Driver or Passenger's Front Doors Handles Inoperable

F30 (3 Series Sedan)

Produced up to February 19, 2015

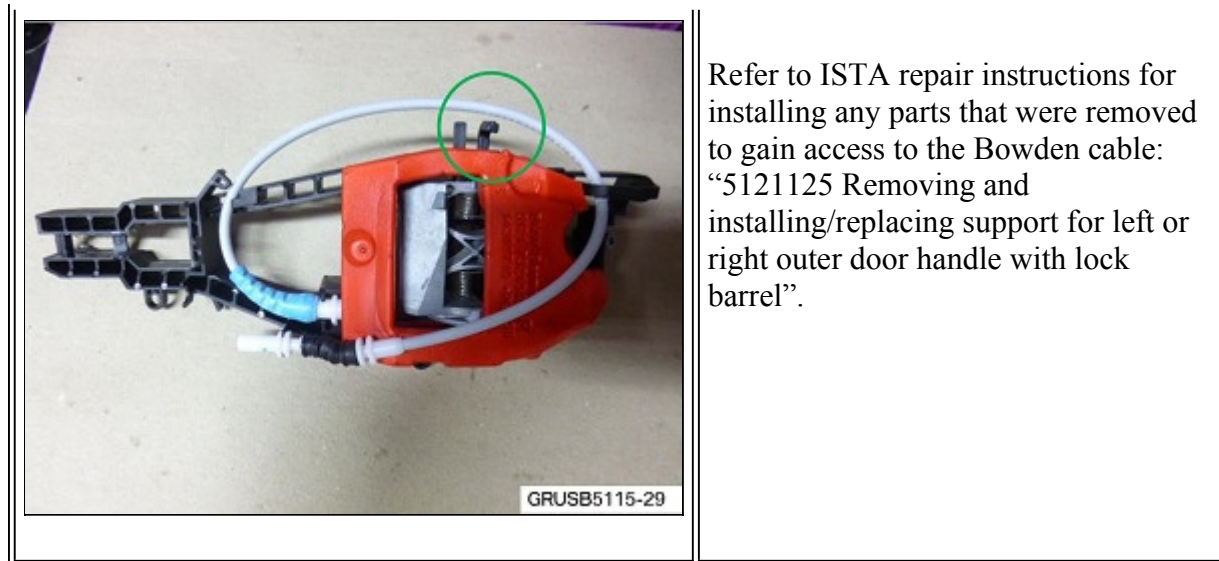
Incorrect routing of the Bowden cable.

This picture shows that the Bowden cable is clipped in place on the support, which is putting unnecessary stress on the cable.

Unclip the cable from the support and retest, to make sure that the door opens freely each time.
